City of Greenville, Ohio
WWTP Solids Handling Facility and Administration Building

ADDENDUM 3

1.16.2025

CIVIL
 NORTHWEST
 SITE AND PAVING
 PLAN
 CITY OF GREENVILLE, OHIO
 WWTP SOLIDS HANDLING FACILITY AND ADMINISTRATION BUILDING

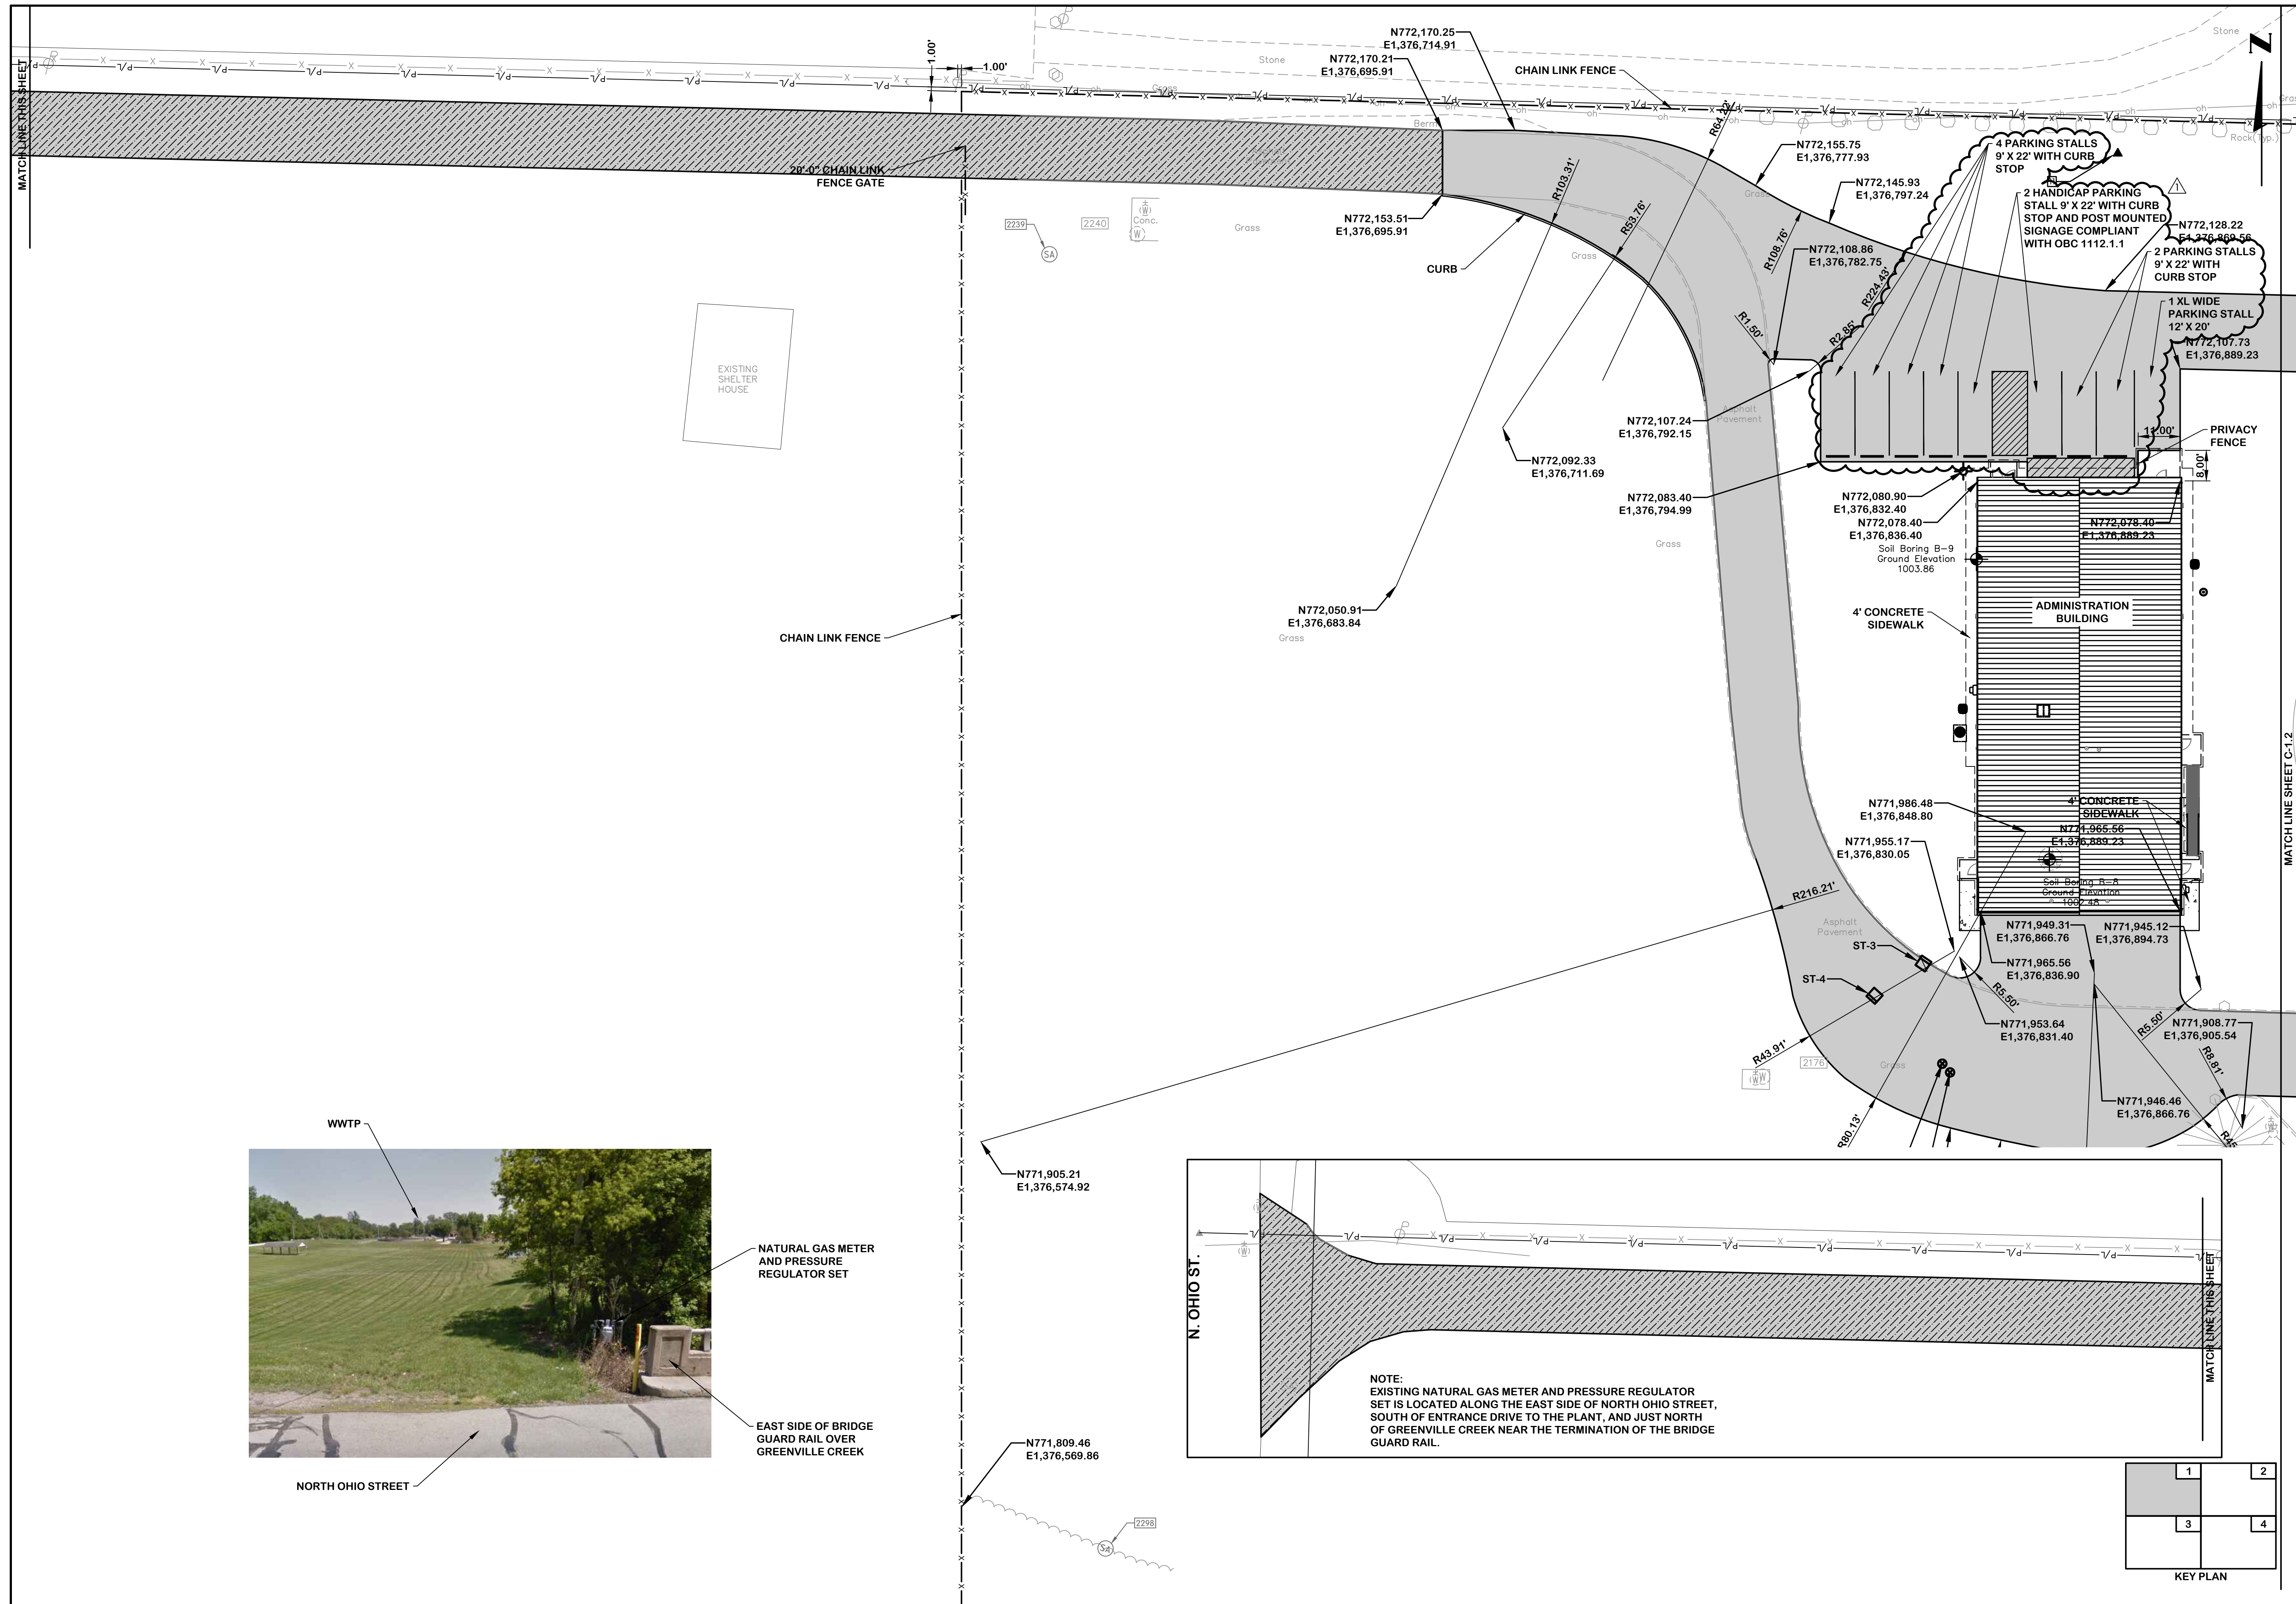
Question: Section 02710 4.02 specifies vinyl fence, but I cannot find any on the print.

Response: *Refer to C1.1 for privacy fence.*

1 SECTION
1/8" = 1'-0"

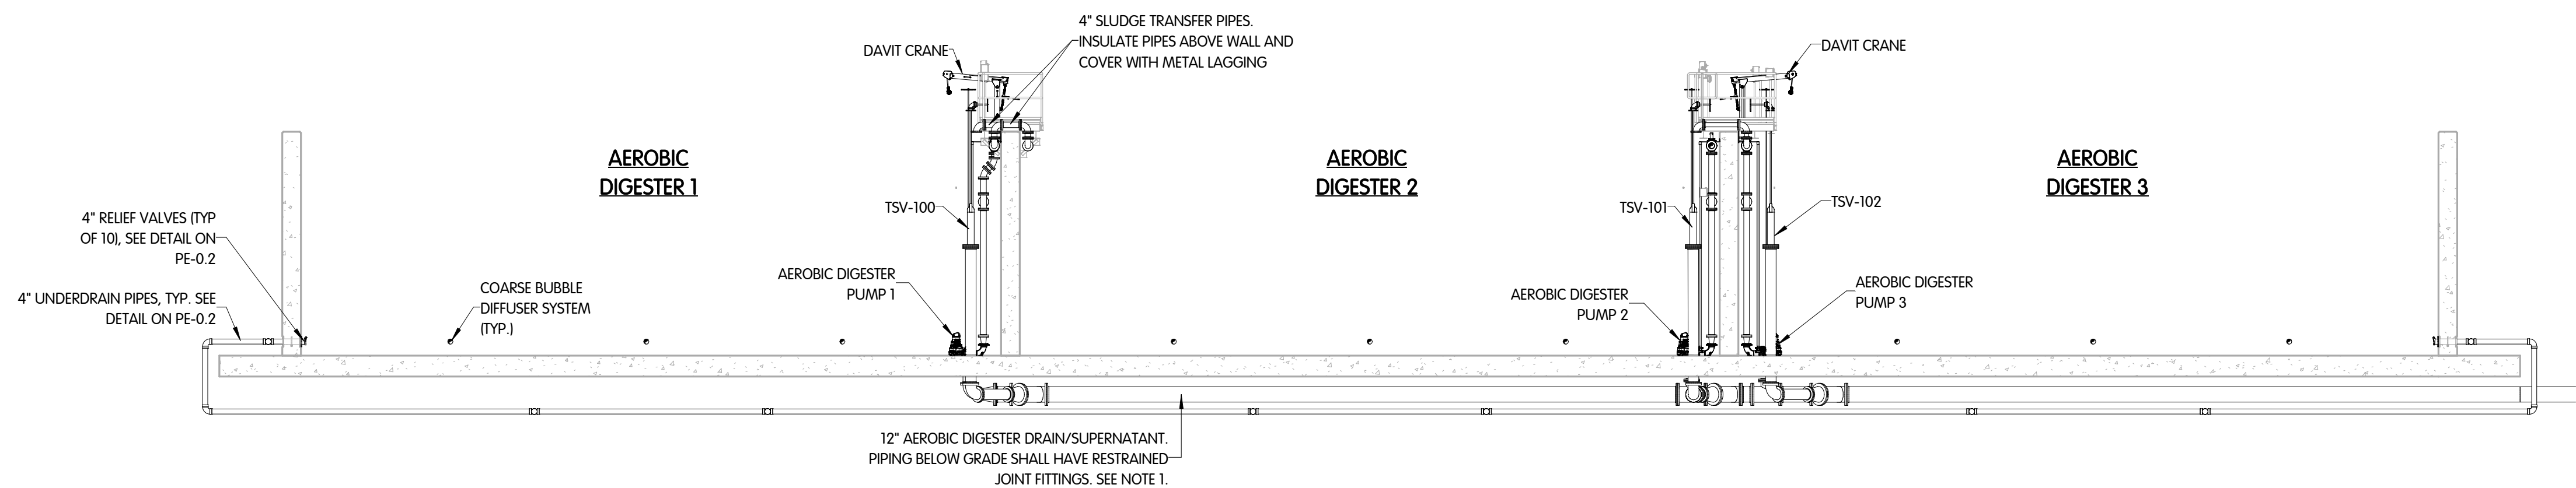
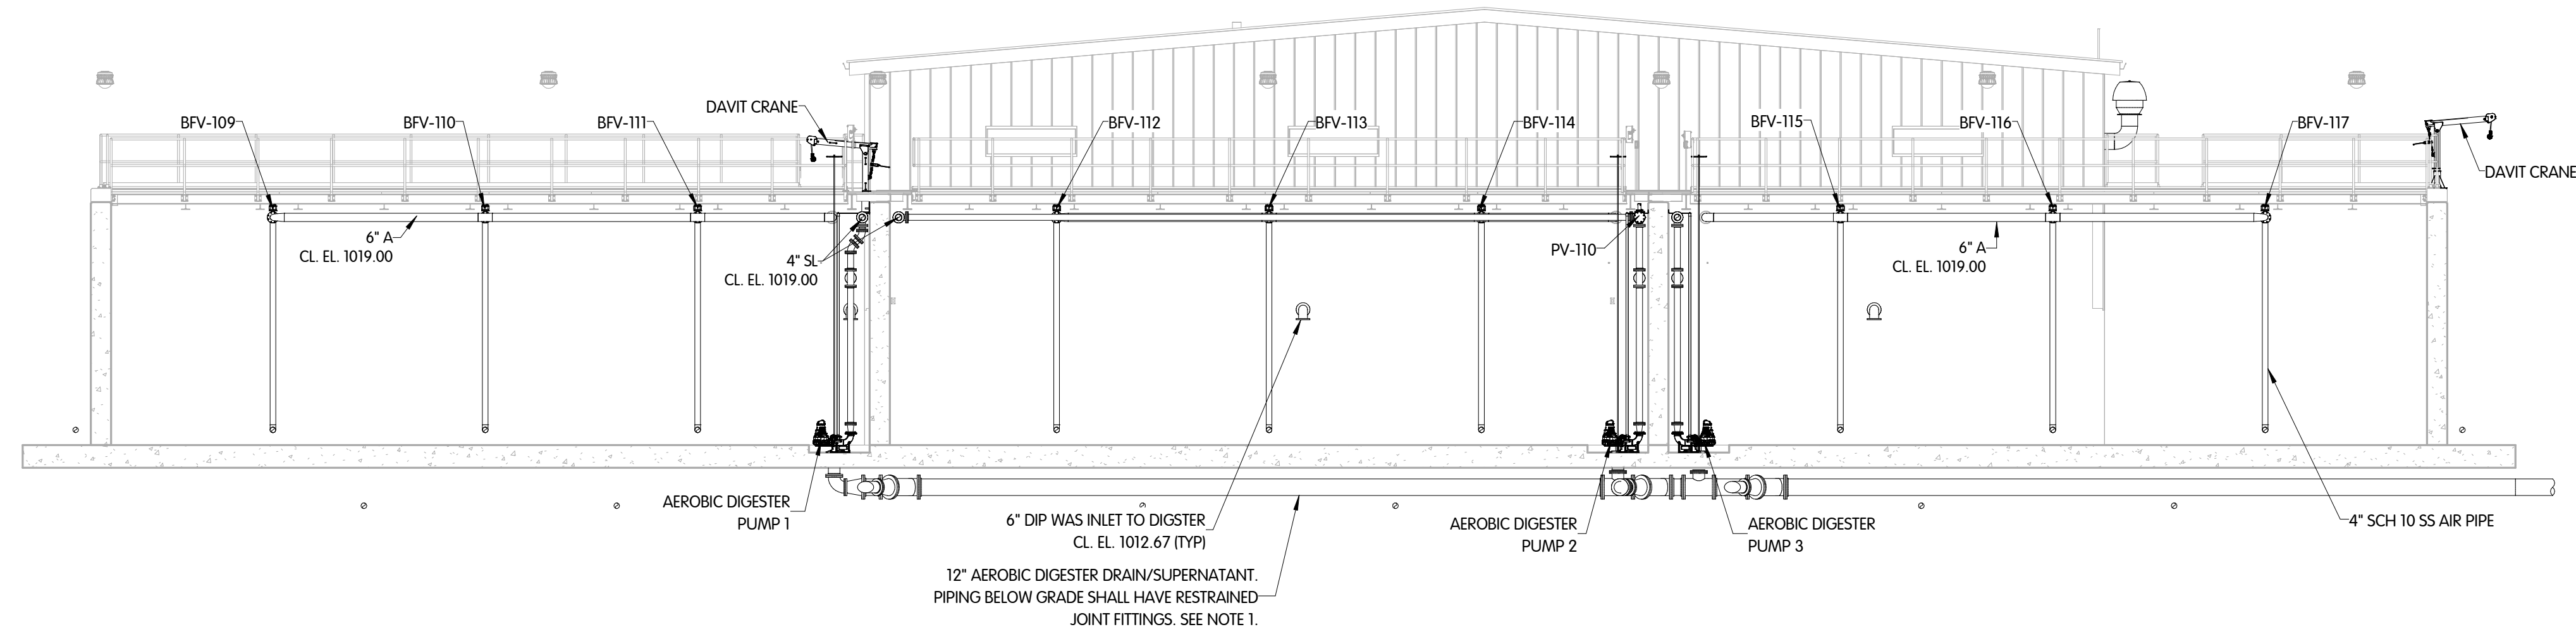
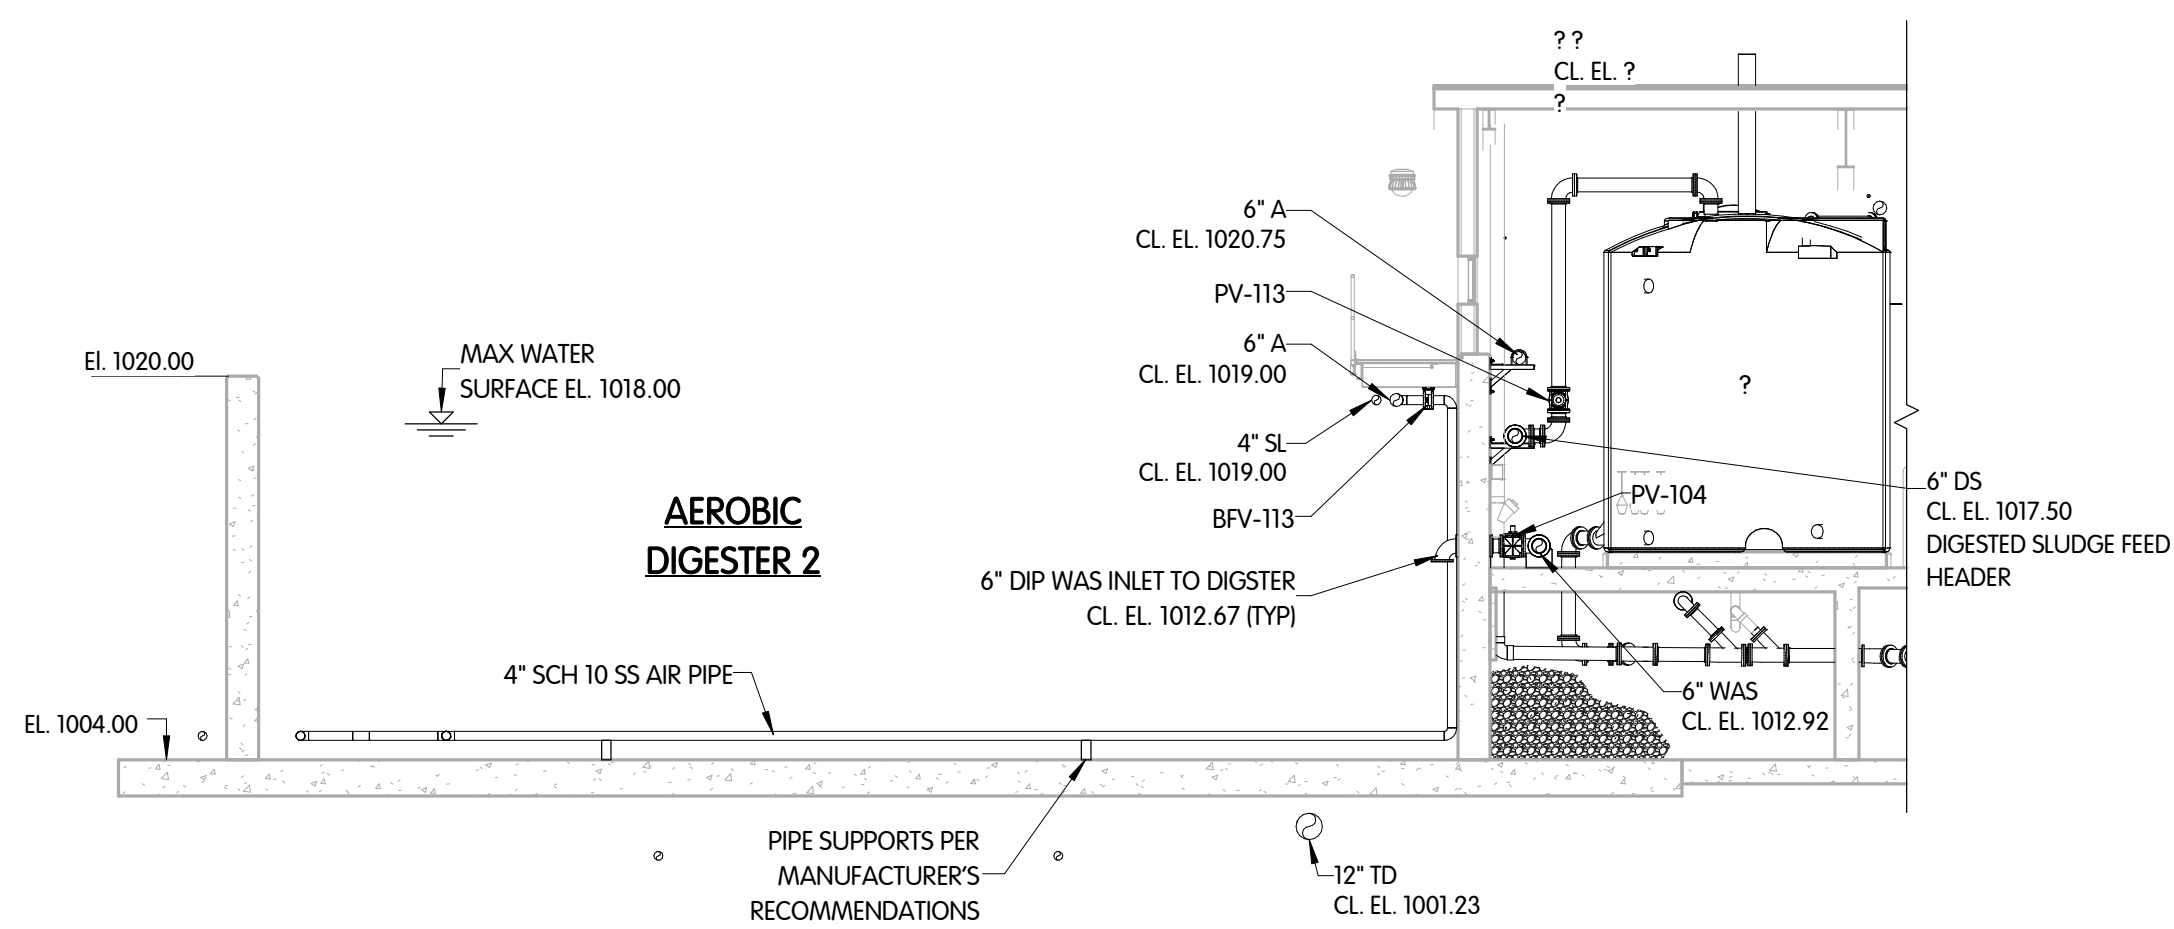
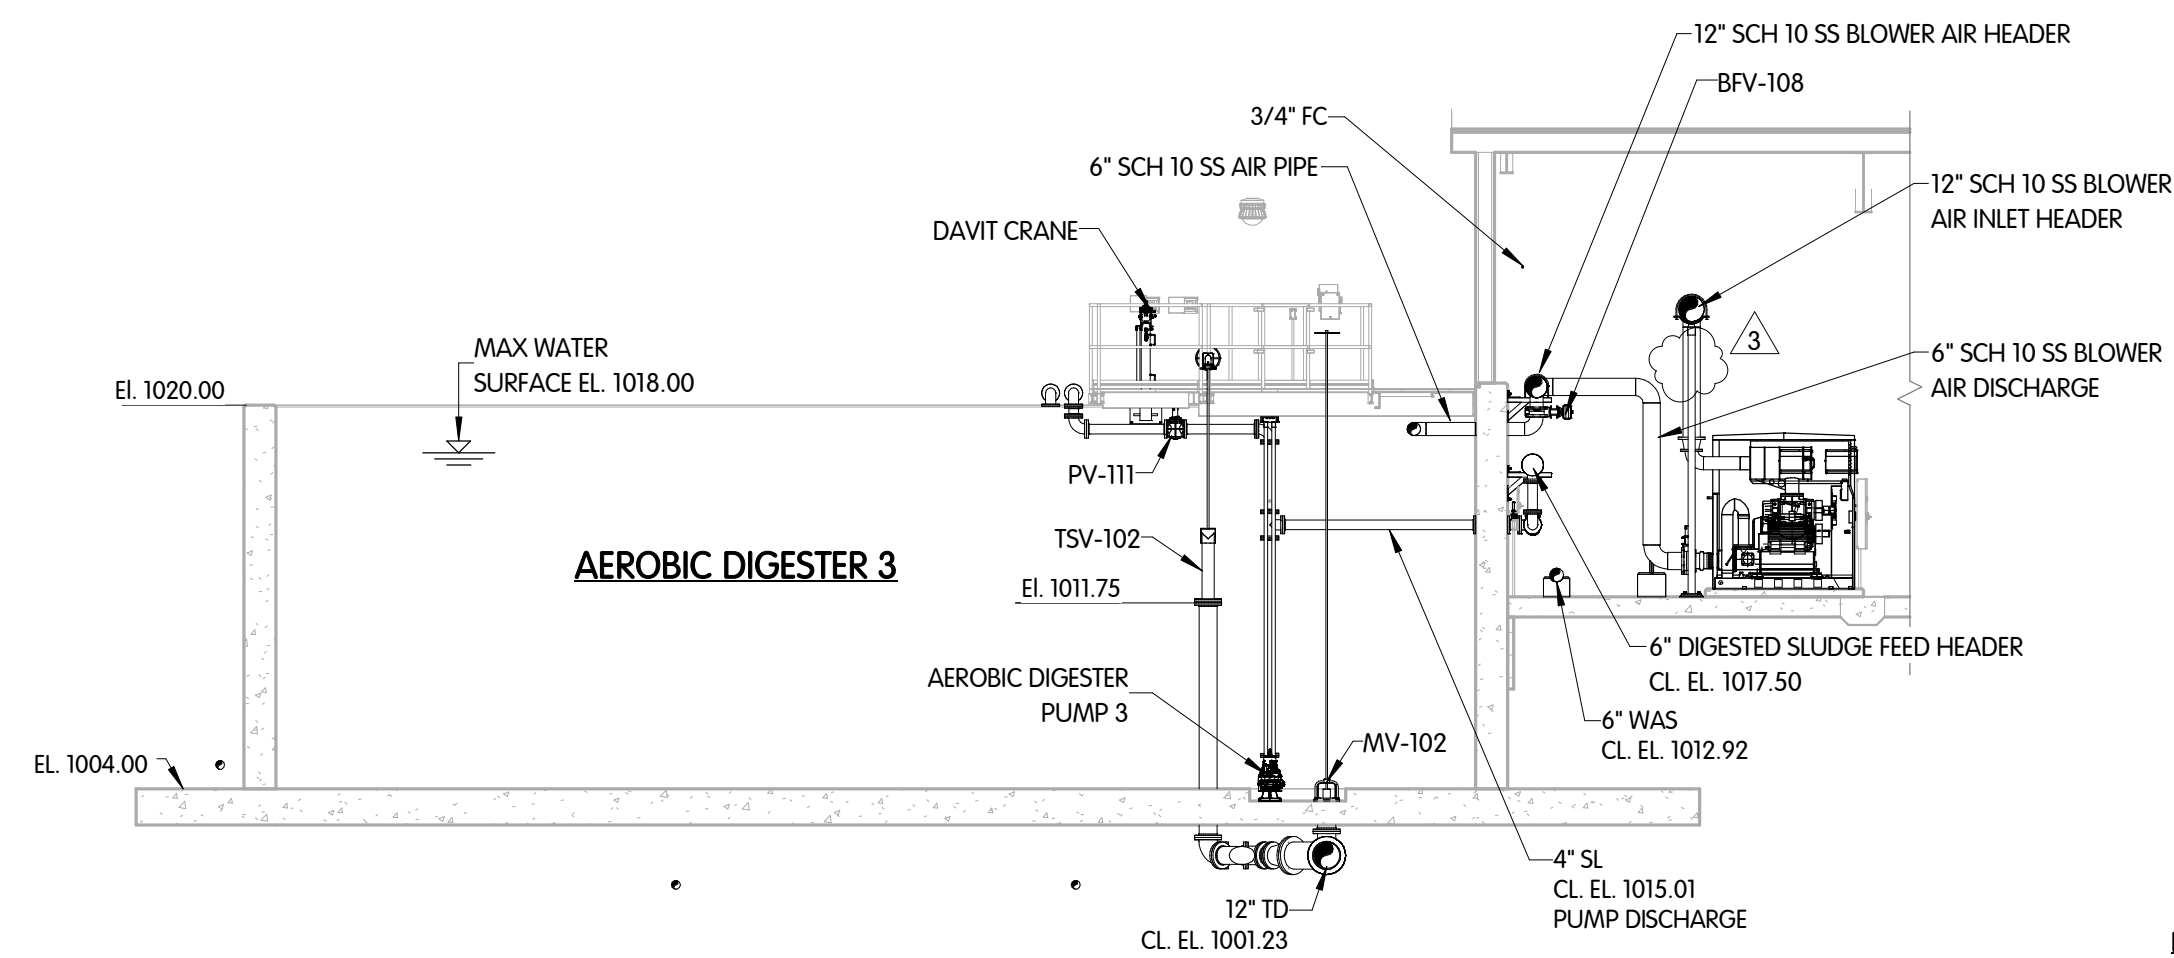
Question: Drawing P1.3 Section 3 shows BFV 123 on the suction side of the blower. We don't recommend butterflies on the suction side. If someone accidentally closes it the blower will collapse the silencer and possibly damage the blower.

Response: *Inlet isolation valves for each blower have been removed. Refer to updated sheets - PE 0.1, PE 1.3, PE 2.3, PE 2.4, G 0.5, and I 0.7 included in Addendum 3.*
